June 22, 2022
Bureau of Ocean Energy Management

Re: Comments on Notice of Intent to develop a Draft Environmental Impact Statement (EIS) on US Wind Marwin and Momentum offshore wind Construction & Operations Plan, BOEM 2022-0025

Figure 3 Effect of wind power projects on experience/enjoyment on recreational beach trips

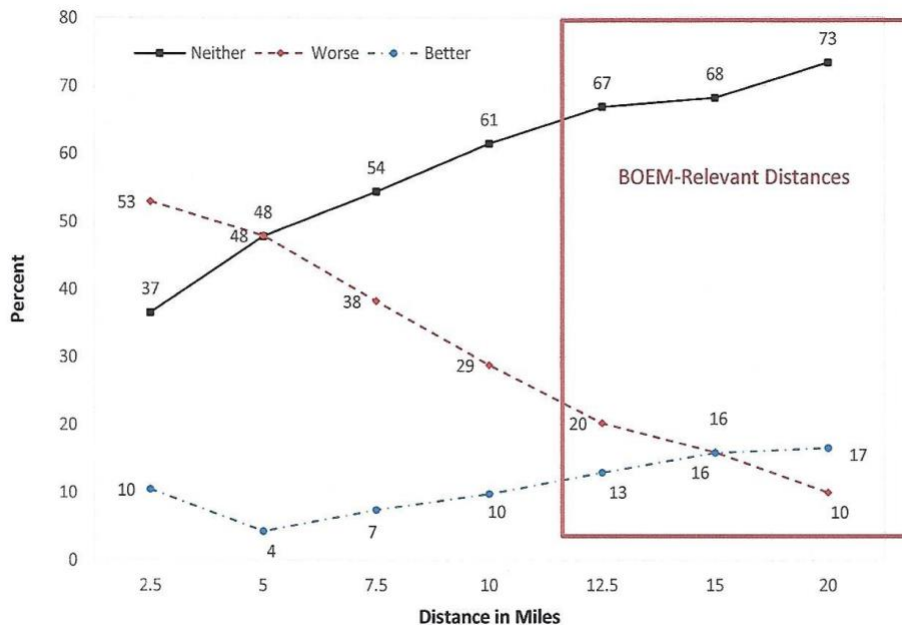
BOEM conducted a study showing visualizations of 600’ tall turbines to survey respondents from 16 points on beaches expected to have future turbines⁷. It ranked the visible impact on a scale from 1 to 6. The visual impact from Jones Beach scored a 6, its worst rating. A 6 rating was defined as; “Dominates the view because the study subject fills most of the field of view in its general direction. Strong contrast in form, line, color, texture, luminance, or motion may contribute to view dominance”. Based on that study New York State recommended no turbines be built within 20 miles of the coast, and BOEM agreed even canceling a lease area 12 miles off the Hamptons⁸. Further supporting exclusion zones BOEM agreed with the National Park Service turbines should be at least 28 miles from Kitty Hawk National Park so they wouldn’t be seen. Also, lease areas were moved 27 miles off the Virginia coast because of potential radar and navigation interference for the Navy port in Hampton Roads.

Clearly, the disruption of the viewshed will be affected in a major way with losses in the \$3 billion/year Delaware, and \$5 billion/year Maryland tourism industry. Property values will also fall. A new study of viewshed effects is needed focused on potential economic impacts of much larger turbines.
